INDIAN POINT NUCLEAR GENERATING UNIT NO. 2

AMENDMENT TO FACILITY OPERATING LICENSE

Amendment No. 111
License No. DPR-26

SAFETY EVALUATION BY THE OFFICE OF NUCLEAR REACTOR REGULATION
RELATED TO AMENDMENT NO. 111 TO FACILITY OPERATING LICENSE NO. DPR-26
CONSOLIDATED EDISON COMPANY OF NEW YORK, INC.
INDIAN POINT NUCLEAR GENERATING UNIT NO. 2
DOCKET NO. 50-247

FIGURE 3.8-1
 LIMITING FUEL BURNUP VERSUS INITIAL ENRICHMENT

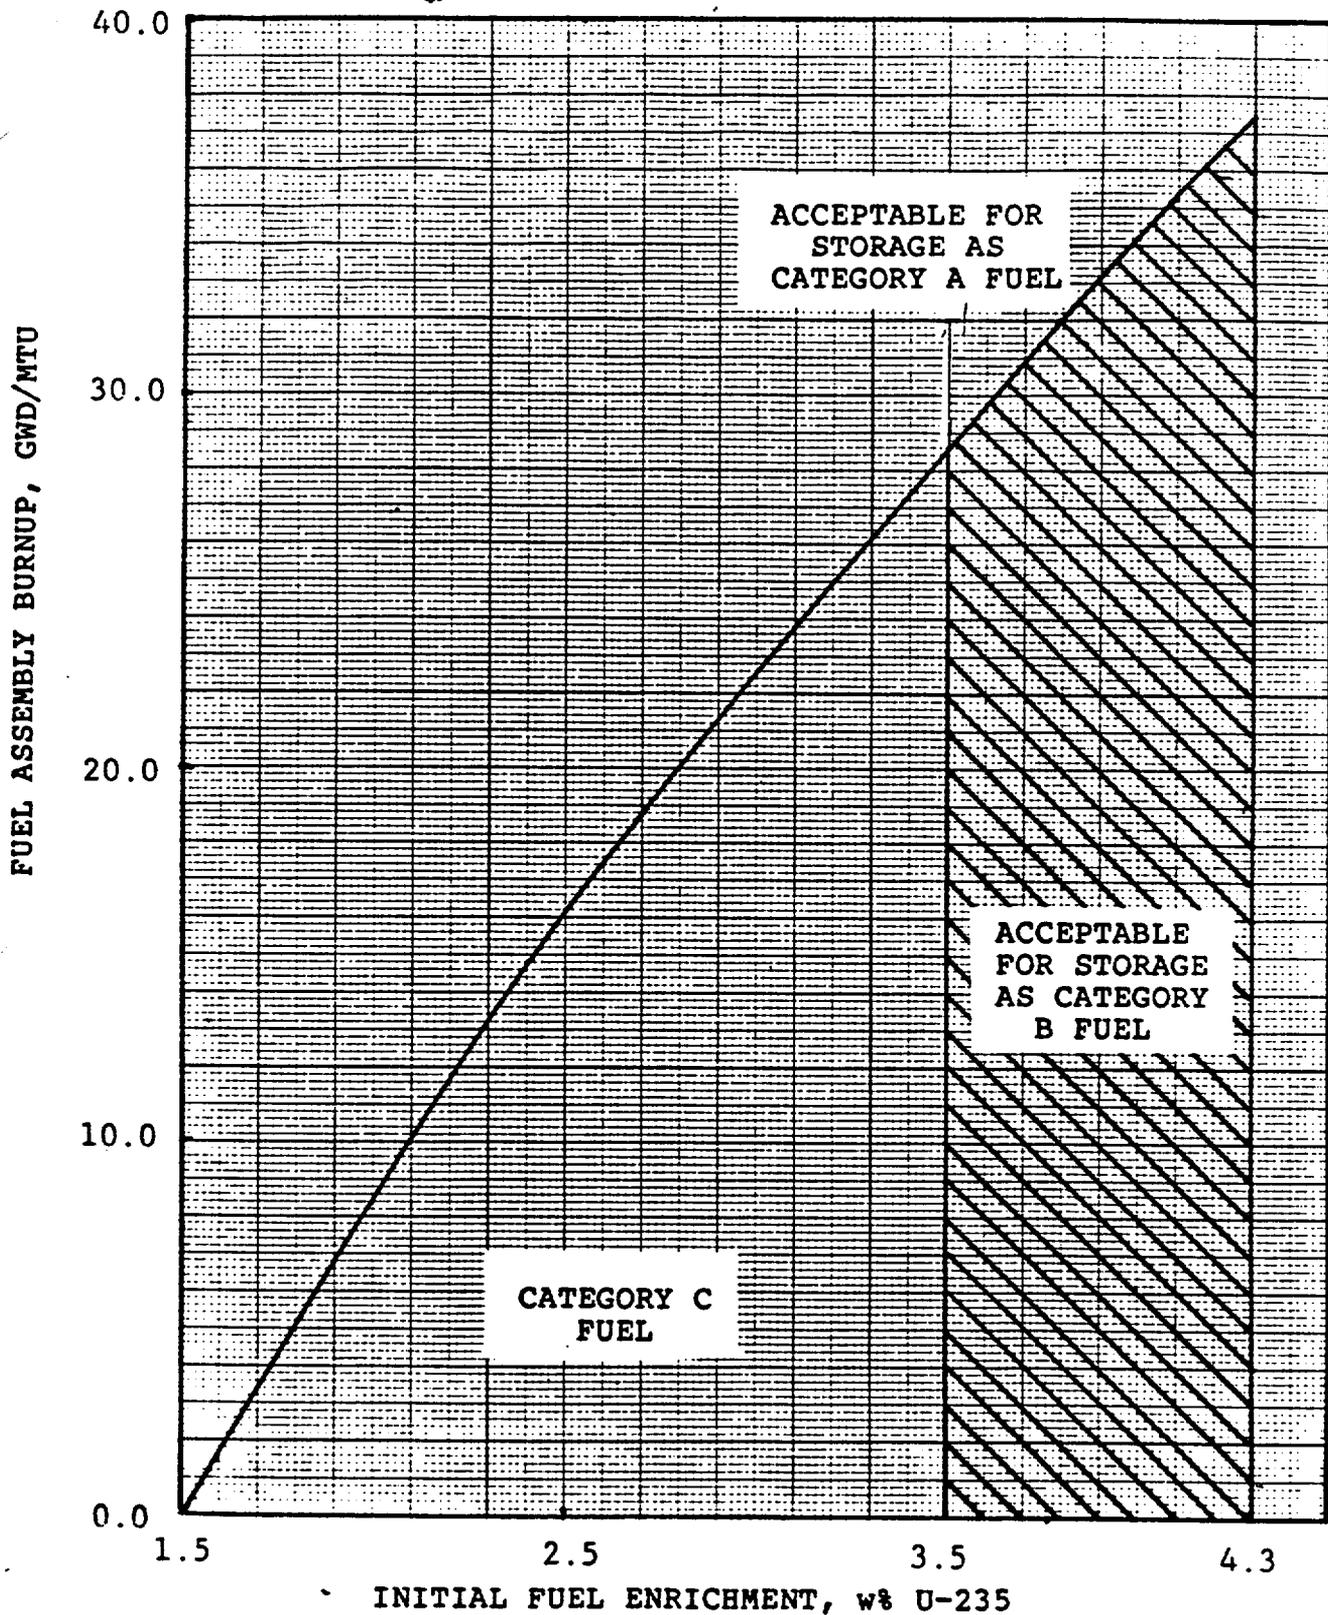
<u>Remove Pages</u>	<u>Insert Pages</u>
vii	vii
3.8-4	3.8-4
3.8-5	3.8-5
3.8-6	3.8-6
-	3.8-7
-	Figure 3.8-1
5.3-1	5.3-1
5.4-1	5.4-1
-	5.4-2

The fuel enrichment and burnup limits in Specification 3.8.C.1 assures the limits assumed in the spent fuel safety analyses will not be exceeded. Within this specification adjacent location means those four locations directly contacting the four sides (faces) of a fuel assembly but excludes those four locations which contact the four corners of a fuel assembly.

CATEGORY A - AREA ALONG THE CURVE AND ABOVE
 CATEGORY B - AREA BELOW THE CURVE AND $3.5 < w\% \text{ U-235} \leq 4.3$
 CATEGORY C - AREA BELOW THE CURVE AND $w\% \text{ U-235} \leq 3.5$

FIGURE 3.8-1
LIMITING FUEL BURNUP VERSUS INITIAL ENRICHMENT

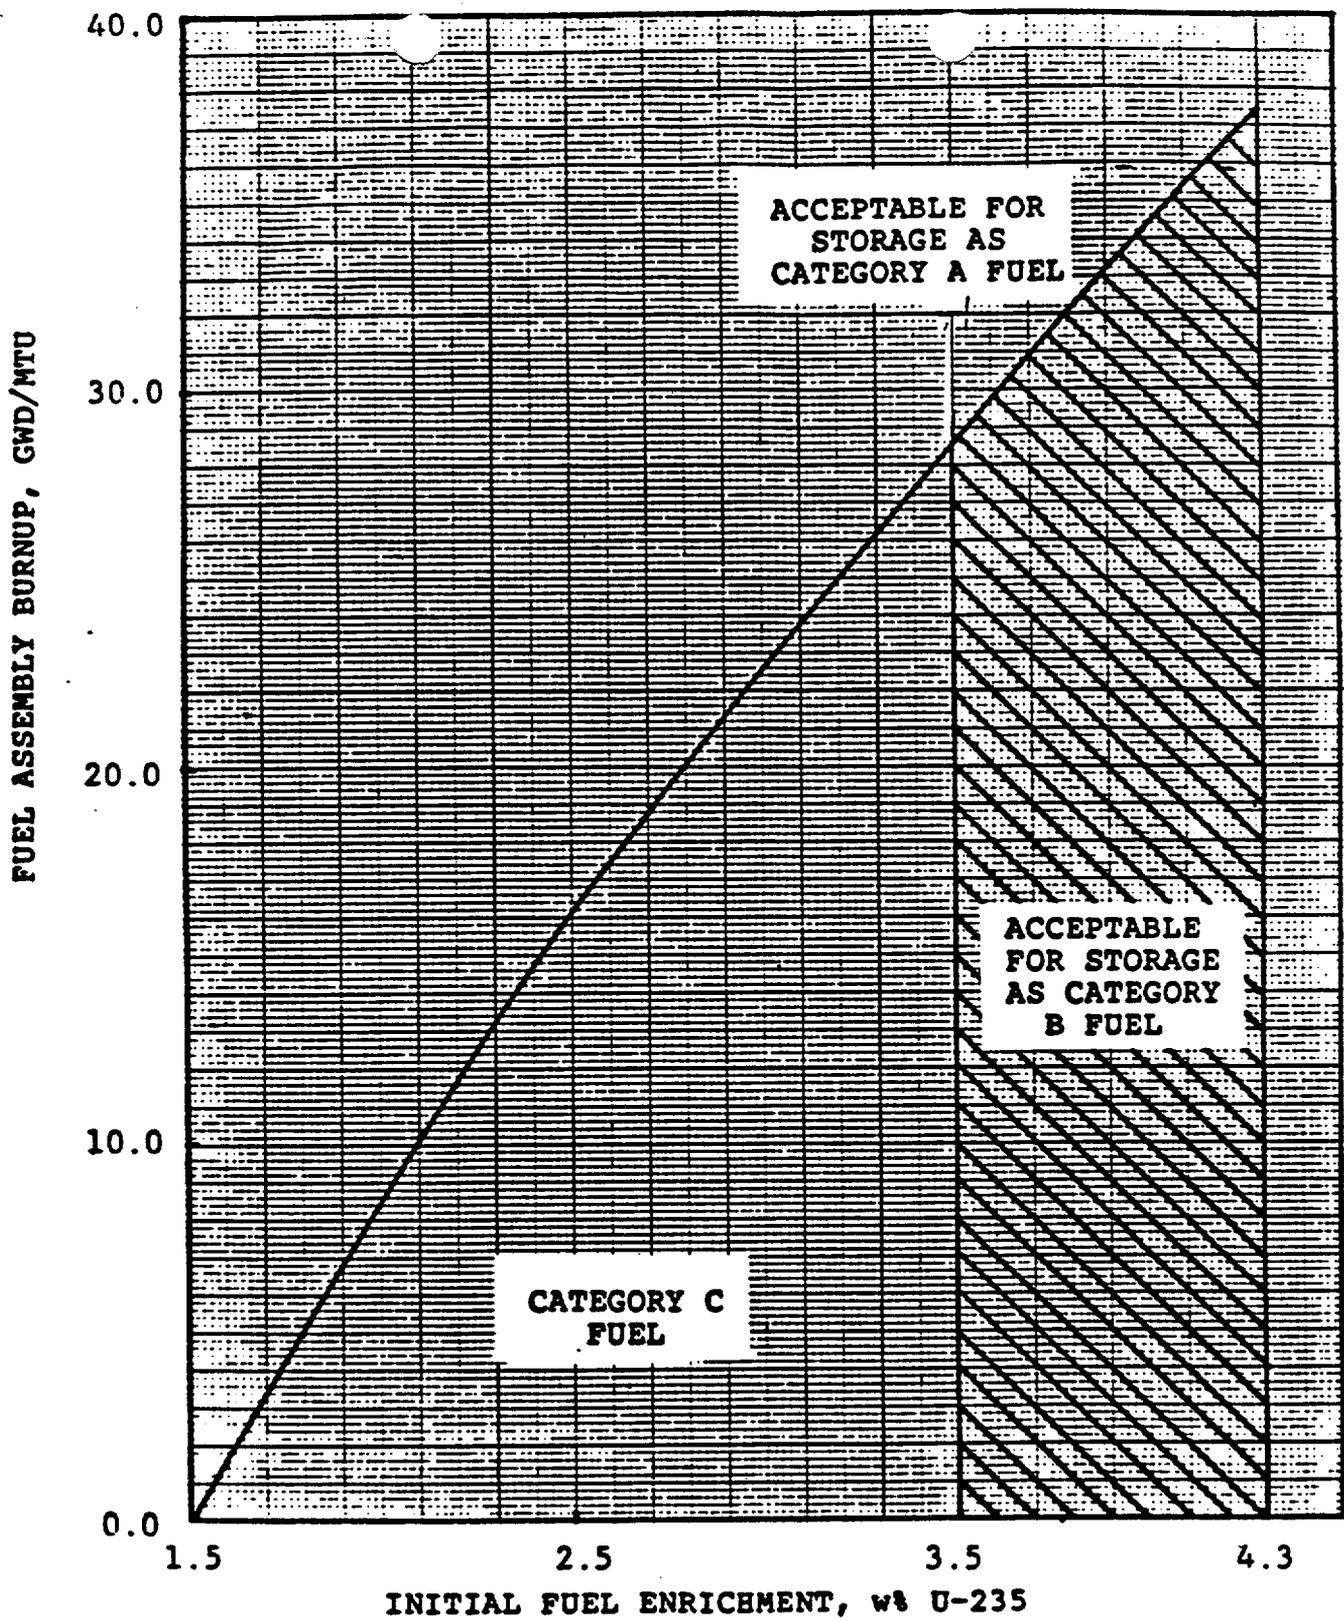
The new specification distinguishes three categories of fuel assemblies (A, B and C) as a function of burnup vs enrichment. The three categories are shown in Fig. 3.8-1 of the Technical Specifications, which is reproduced on the next page. Technical Specification 3.8.C.1 proposes to load category B assemblies in the spent fuel pool in a checkerboard pattern, neighboring (on the sides) only with category A assemblies. The category C assembly storage within the pool is unrestricted except that they cannot be loaded adjacent to category B fuel assemblies. This arrangement with the burnups and enrichment specified in Fig. 3.8-1 assures that the limits assumed in the safety analyses of the spent fuel pool will not be exceeded. The substantive change is the increase of the initial fuel enrichment from 3.5 to 4.3 w/o U-235. The checkerboard loading pattern will maintain $k_{eff} \leq .95$ as provided in section 9.1.2 of the Standard Review Plan. The k_{eff} estimate is discussed in paragraph 2.4 below.

The methodology, in this calculation used the CASMO-2E and PDQ-7 codes (References 4 and 5) to assess enrichment vs depletion. The CASMO-2E solution for the Indian Point 2 pool was used to benchmark the calculation against the original (reference) calculation and to provide macroscopic cross sections for non fuel regions for use in the PDQ-7 code. (References 9 and 10). Depletion dependent macroscopic cross sections as a function of initial enrichment, were used which in turn were used to derive burnup as a function of initial enrichment for a constant k_{eff} . CASMO fuel rack and fuel assembly models were developed, which generated the necessary cross sections for a PDQ-7 rack and fuel assembly model. The last was applied to determine the checkerboard arrangement of 4.3 w/o U-235 and depleted assembly loadings. This process yielded Fig 3.8-1 shown previously.

assemblies was carried out on a 4 1/4 assembly configuration with reflecting boundary conditions. Two of the 1/4 assemblies were 4.3 w/o U-235 and the other two were depleted. The k_{eff} value in Figure 3.8-1 at 1.5 w/o U-235 and zero burnup is .906. Then this k_{eff} was held constant for increasing burnup and enrichment. In this manner the category A fuel is determined to be above the $k_{eff} = .906$ line. A justification of the biases and uncertainties of the calculation was submitted in the additional information (Reference 3). The uncertainties and biases were conservative and, hence, acceptable.

CATEGORY A - AREA ALONG THE CURVE AND ABOVE
 CATEGORY B - AREA BELOW THE CURVE AND $3.5 < \text{wt U-235} \leq 4.3$
 CATEGORY C - AREA BELOW THE CURVE AND $\text{wt U-235} \leq 3.5$
